SUBJECT: Supplement to Amendment Request NPF-38-249,
Extended Power Uprate
Waterford Steam Electric Station, Unit 3
Docket No. 50-382
License No. NPF-38

Response to Request for Additional Information

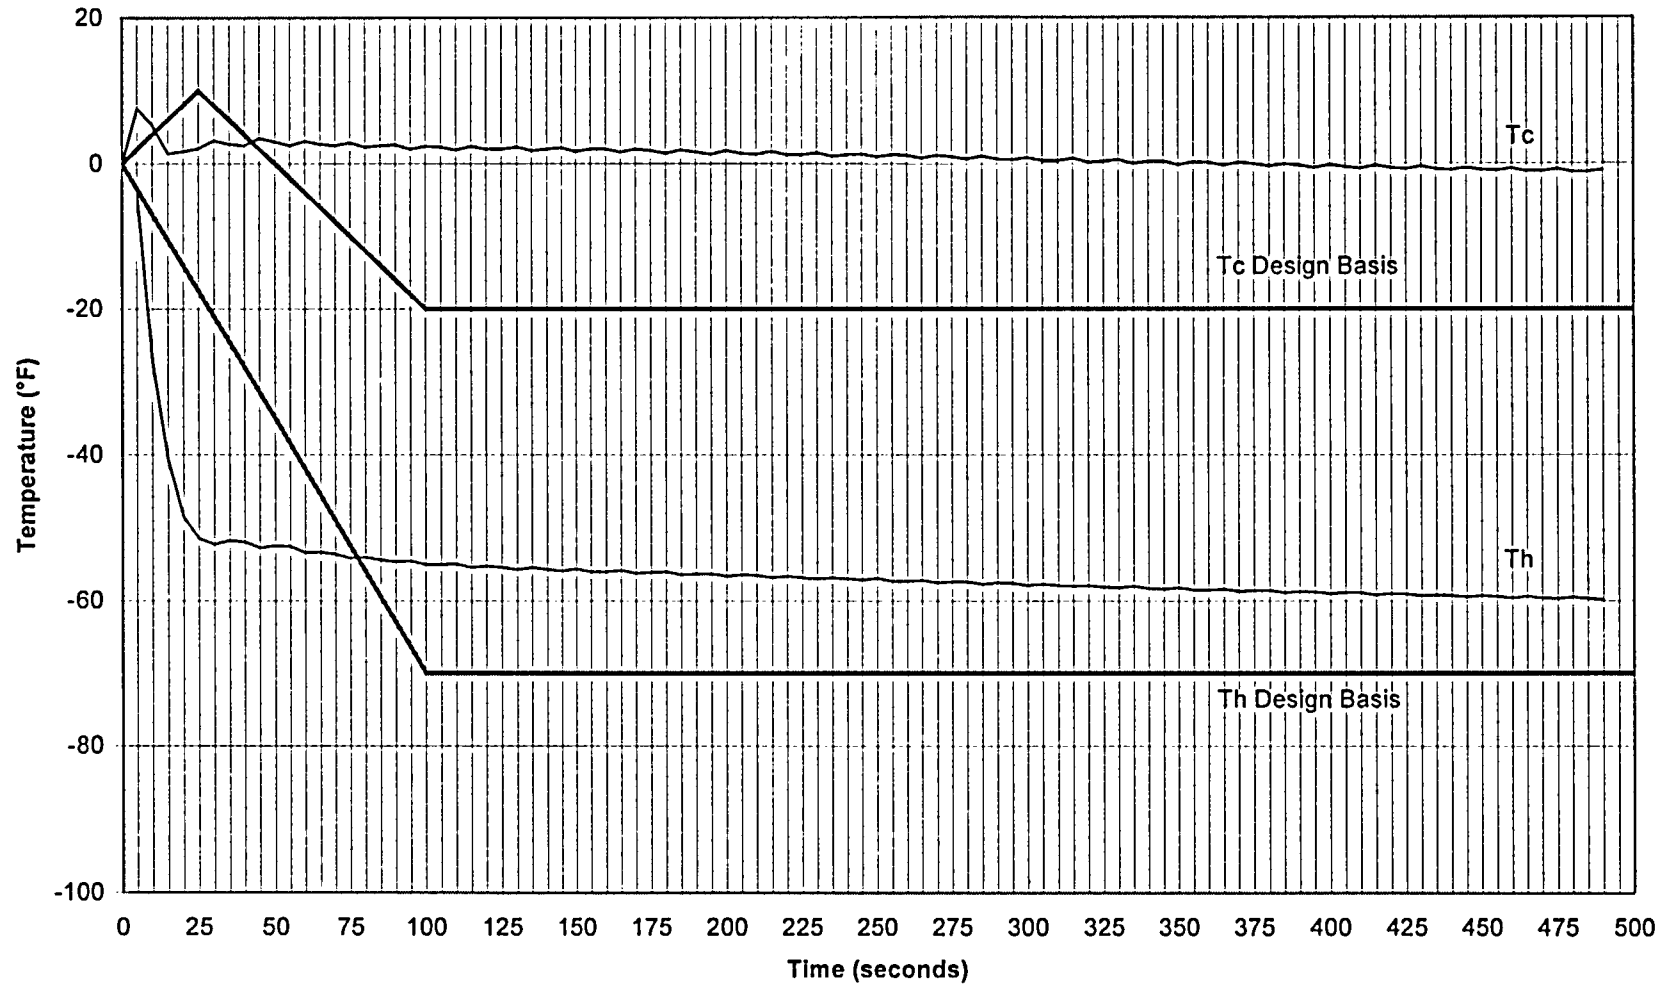
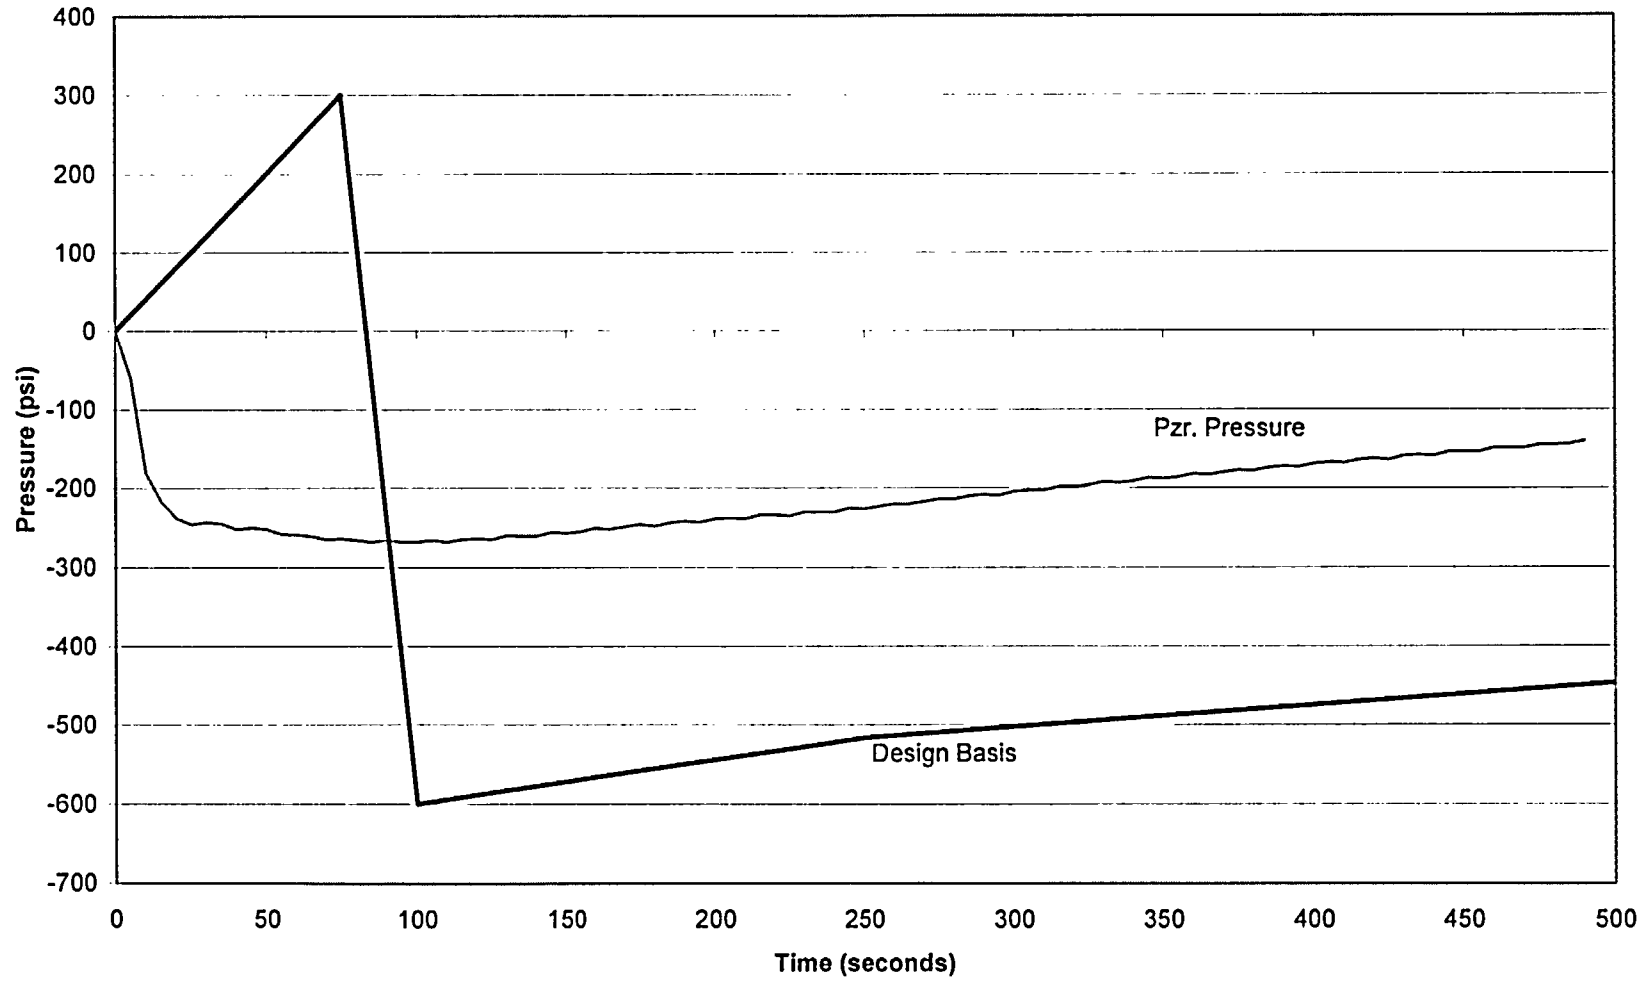
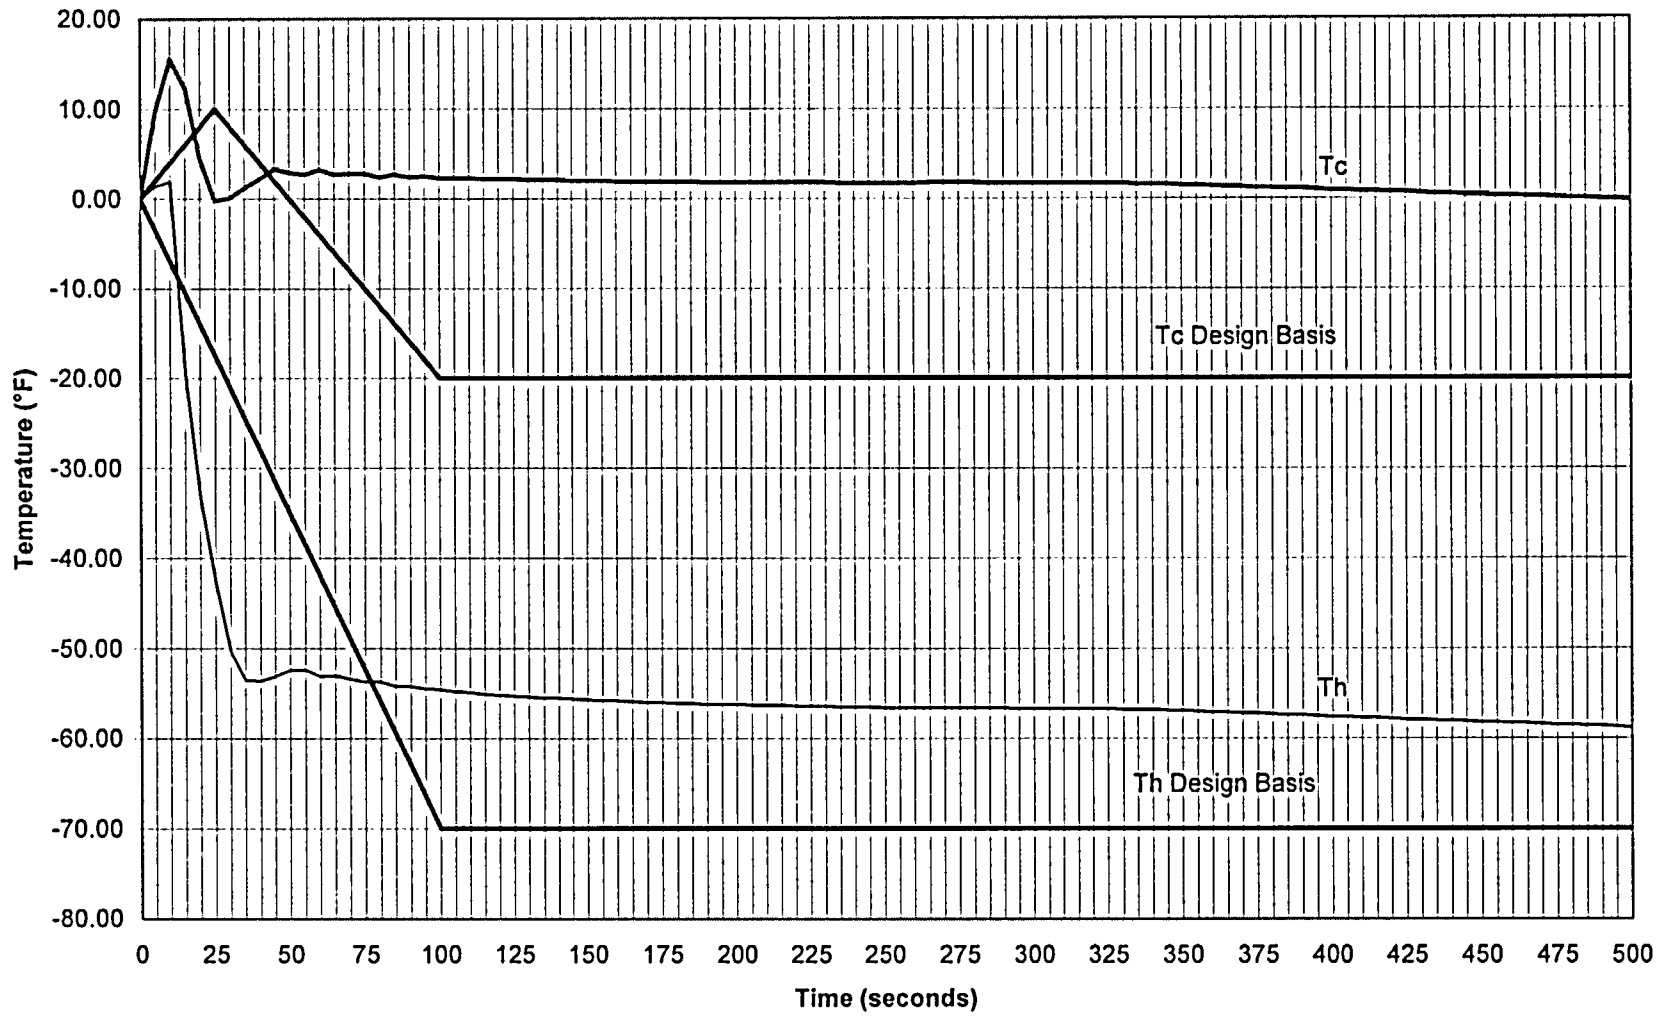
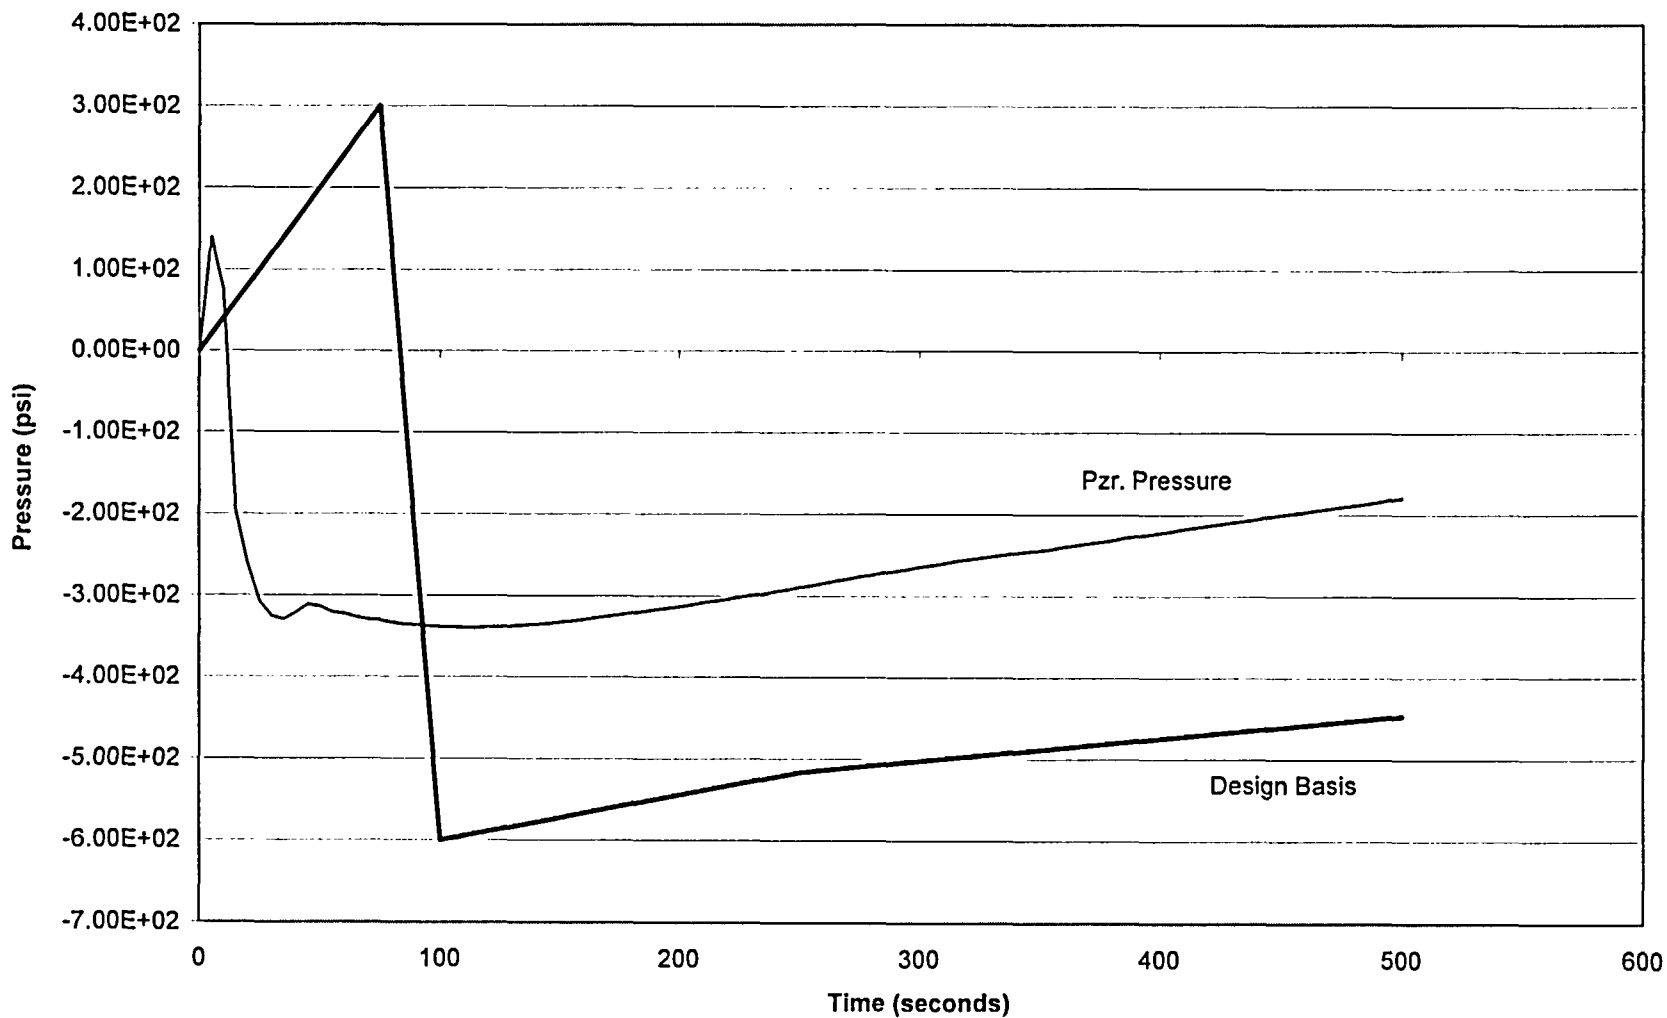
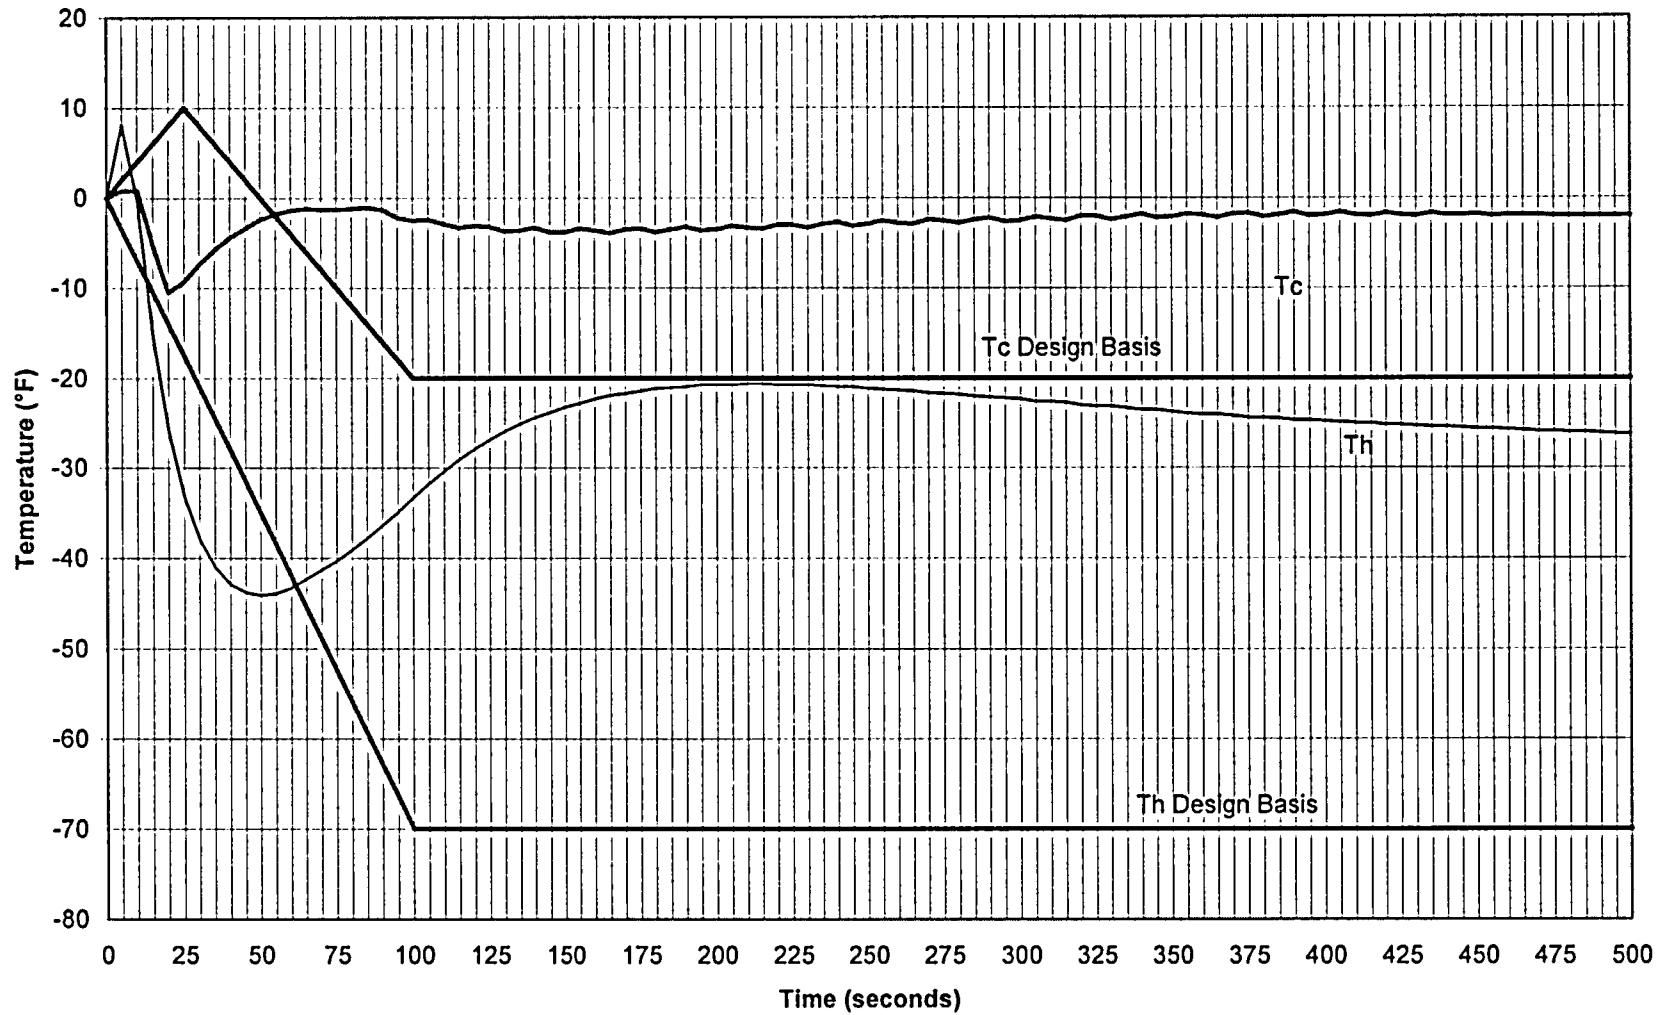
In Section 2.2.2.1.1, you indicated that power uprate resulted in minor changes to as-calculated normal operation transients, and a detailed evaluation of the changes in stresses and fatigue levels in the Reactor Coolant System (RCS) due to these transients was performed to demonstrate that the originally specified design transients for Waterford 3 remain applicable under Extended Power Uprate (EPU) conditions. This was accomplished by demonstrating that transients affected by EPU have no significant effect on the stresses or cumulative usage factors (CUFs) of the limiting RCS components. Provide a comparison of transients at the power uprate conditions to the original design-basis transients with respect to the number of occurrences and changes in pressure and temperature in the stress and cumulative fatigue usage calculations.

The originally specified design transients were evaluated for the potential effect EPU would have on them. The same list of events and number of event cycles were maintained for the EPU design transient evaluation. The Reactor Trip, Loss of Load, Loss of Flow and Loss of Secondary Pressure events were rerun using EPU conditions. The plots for the rerun cases are attached. The rerun cases and results of the evaluation were documented and evaluated for any effects on stress and fatigue levels.
